Groundwater Application Review Summary Form

Application # G- 18577

PUBLIC INTEREST REVIEW FOR GROUNDWATER APPLICATIONS

TO: Water Rights Section Date 08/15/2018
 FROM: Groundwater Section Phillip I. Marcy
 Reviewer's Name
 SUBJECT: Application G- 18577 Supersedes review of _____
 Date of Review(s)

Well Location Map

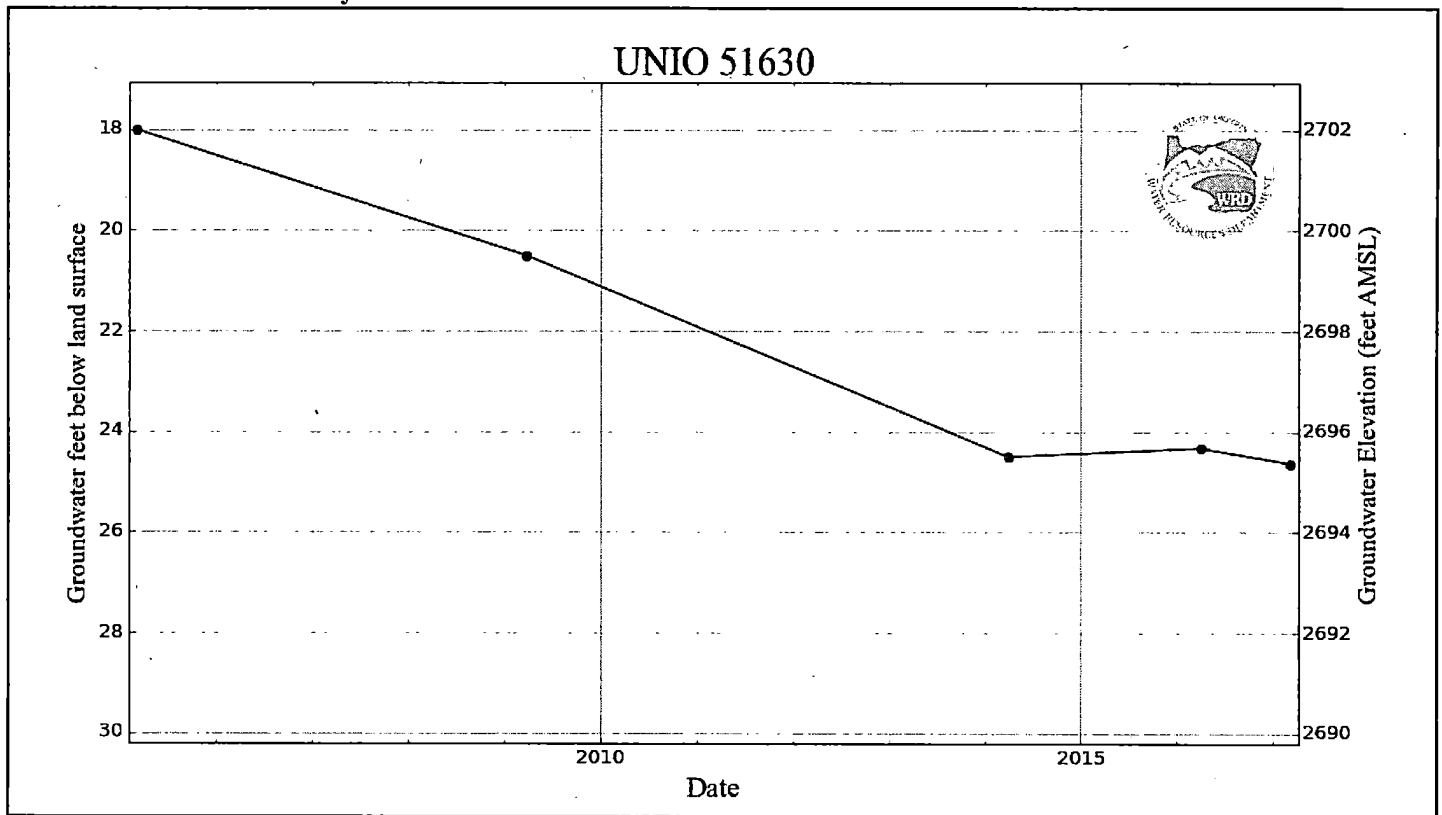
Nearby senior water rights are approximately 3,000 feet from proposed POA 1, where the vast majority of pumping is proposed to occur. Using aquifer parameters reported by Ham (1966), and situational parameters from the well log database and site information file, the maximum drawdown at the closest groundwater POA during the first year of pumping is expected to be in the range of 1-5 feet.
